# REGIONAL REVIEW NOTIFICATION

**Name of Proposal:** Majestic Airport Center III  
**Review Type:** Development of Regional Impact

Preliminary Report:	March 3, 2005	<b>DEVELOPMENT OF REGIONAL IMPACT REVIEW REPORT</b>	Project:	Majestic Airport Center III # 705
Final Report Due:	April 2, 2005		Comments Due By:	March 17, 2005

PRELIMINARY SITE PLAN

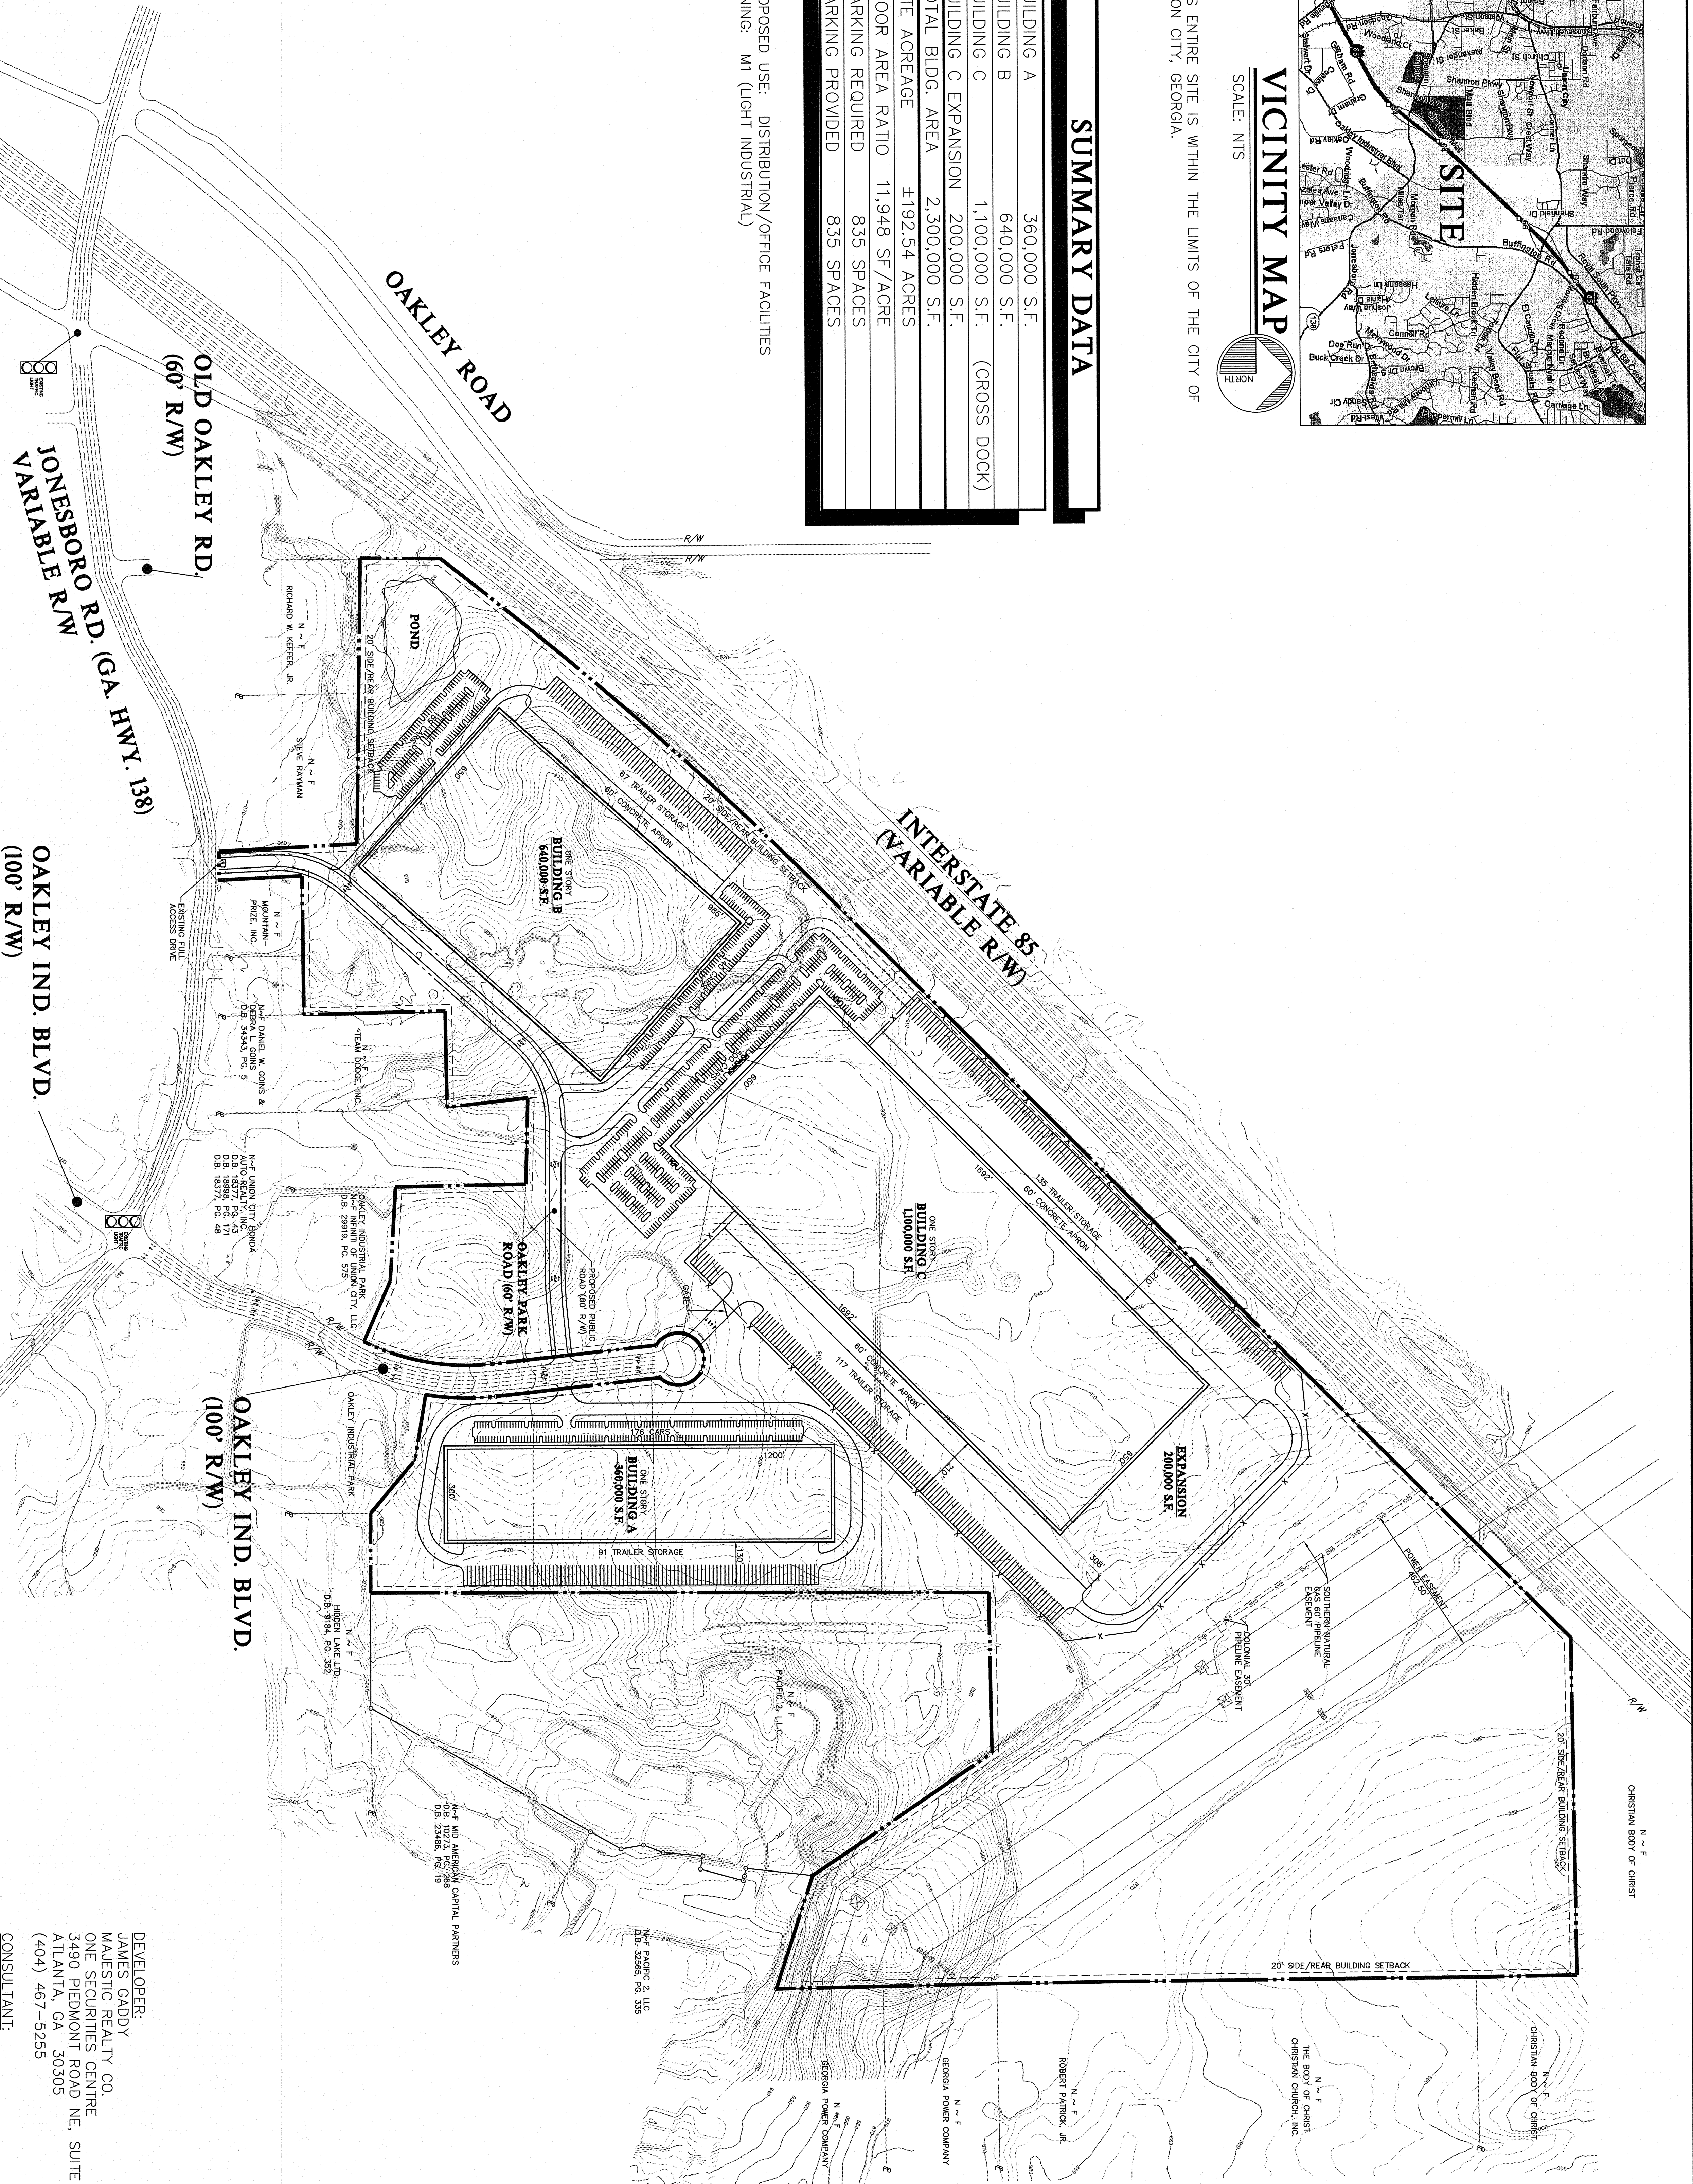
A stream runs across the northern portion of the property partly within the existing utility easements. No buffers are shown along the stream. The 25-foot buffer required under the State Erosion and Sedimentation Act, as well as any required City stream buffers should be shown on the project plans, even when no development activity is proposed near the stream. In addition, all waters of the state on the property, not just the stream, are subject to the State 25-foot Erosion and Sedimentation Act buffers. These buffers are administered by the Environmental Protection Division of the Georgia Department of Natural Resources. Any work within the Erosion and Sedimentation buffers will require a variance from EPD.
